**Improved Flammability Standards for
Materials Used in the Interiors of
Transport Category Airplane Cabins; Final
Rule**

[Docket No. 26192, Amendments Nos. 25-83, 121-247 and 135-55]

ACTION: Final rule.

Figure 1A Rate of Heat Release Apparatus

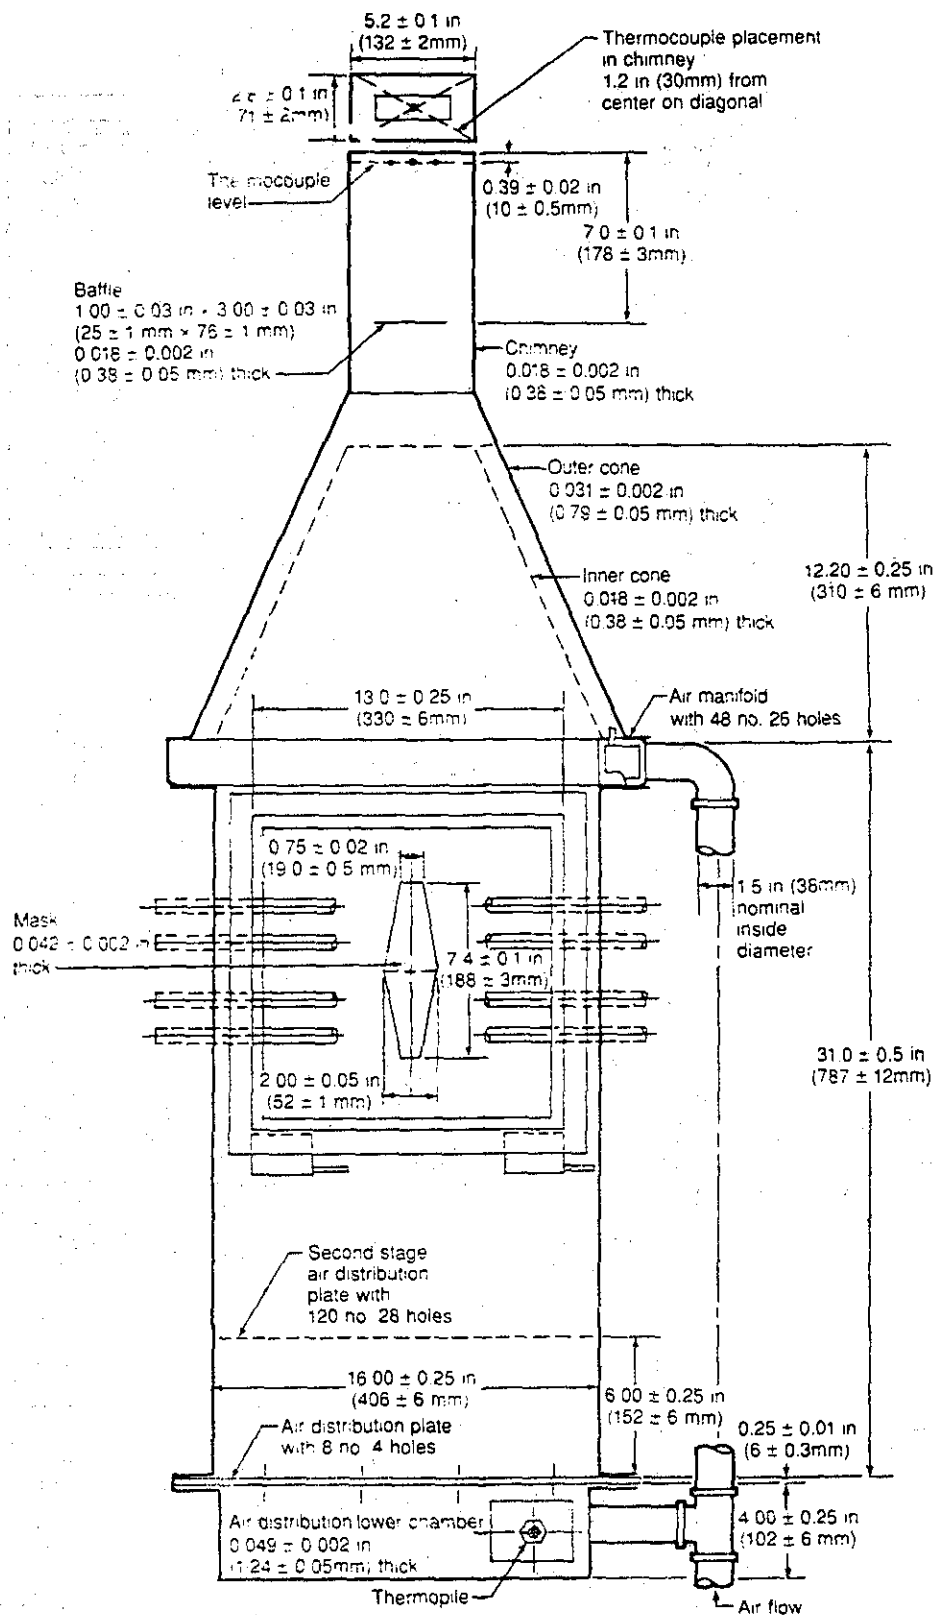
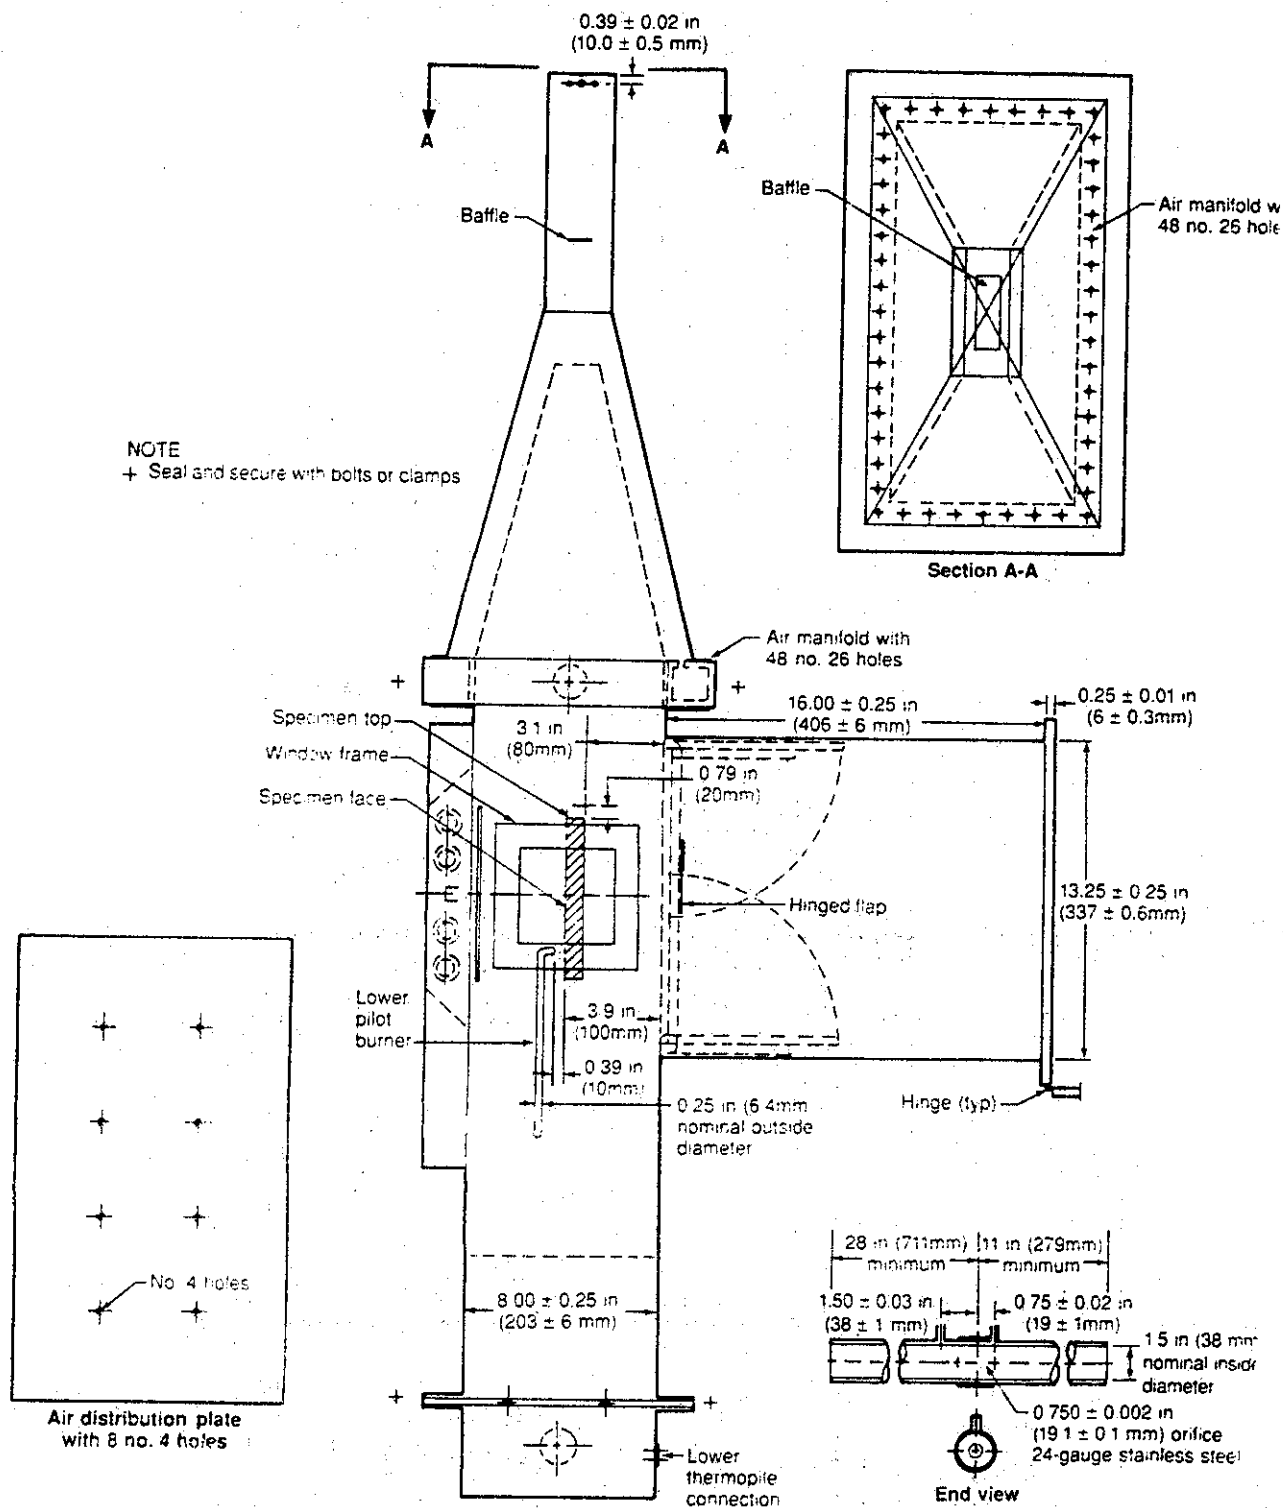
3. By amending part IV of Appendix F to Part 25 by revising paragraphs (a), (b)(1) through (6), (b)(8), (c)(1), (d) heading and (d)(1), (d)(3), (e)(1) through (5), (e)(8), (f)(2), and by adding paragraph (c)(3); transferring Figures 1 through 5 at the end of Appendix F to the end of part IV of Appendix F and adding a heading preceding the figures, and by removing Figure 1 of part IV and adding Figures 1A and 1B in its place to read as follows:

points, located 1.5 inches (38 mm) upstream and .75 inches (19 mm) downstream of the orifice plate. The pipe must be connected to a manometer set at a pressure differential of 7.87 inches (200 mm) of Hg. (See Figure 1B of this part IV.) The total air flow to the equipment is approximately .04 m³/seconds. The stop on the vertical specimen holder rod must be adjusted so that the exposed surface of the specimen is positioned 3.9 inches (100 mm) from the entrance when injected into the environmental chamber.
